SERVICE CAMPAIGN BULLETIN

CAMPAIGN REF: 012

TITLE : Check the serial number of the Tyre Pressure Monitoring System (TPMS) control unit and replace if necessary

AFFECTED VEHICLES : 12C Coupe

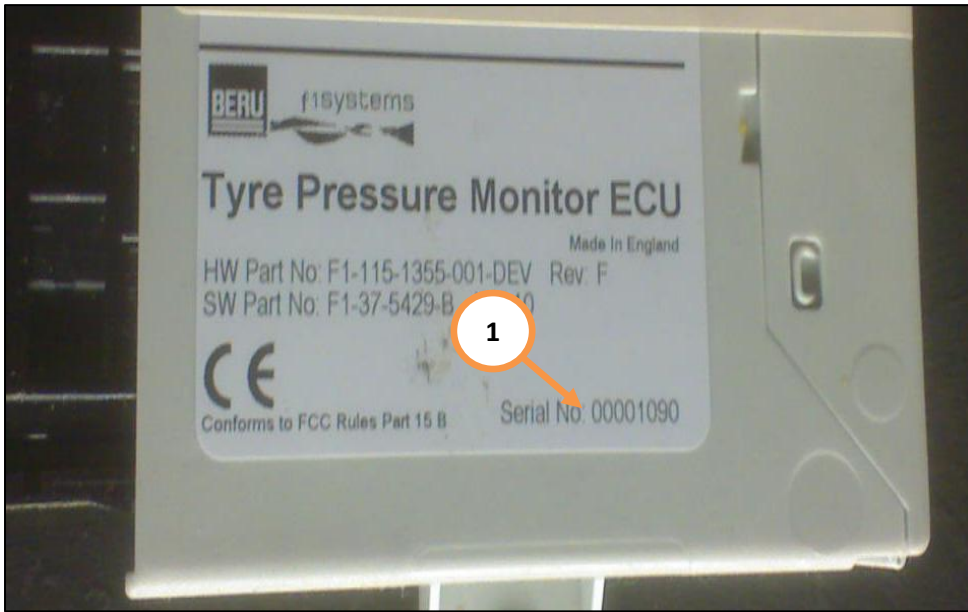
SITUATION : Quality Engineering at McLaren Automotive have identified that a number of vehicles have been fitted with TPMS control units that potentially can lose communication with the sensor triggers, causing spurious TPMS warning messages to appear in the instrument cluster.

PROCEDURE : Check the TPMS control unit number. If the vehicle is fitted with a control unit that has a serial number between 00001682 & 00002191, the TPMS control unit should be replaced.

1. A-RM-02A02-03-004 - Remove/install luggage bin - Rear
2. A-RM-06N06-01-008 - Remove/Install B-Pillar finisher
3. A-RM-06N06-01-008 - Remove/Install B-Pillar finisher
4. A-RM-06N06-01-005 - Remove/install rear quarter trim
5. A-RM-06N06-01-003 - Remove/install carpet - fuel cell & bulkhead
6. A-RM-05M01-01-007 - Remove/install false floor - Electric city
7. Inspect TPMS module serial number (1). Control units with a serial number between 00001682 & 00002191 should be replaced.
8. If the TPMS control unit requires replacement, the serial number must be entered into the Retailer Comments box (2) within the Work Package.
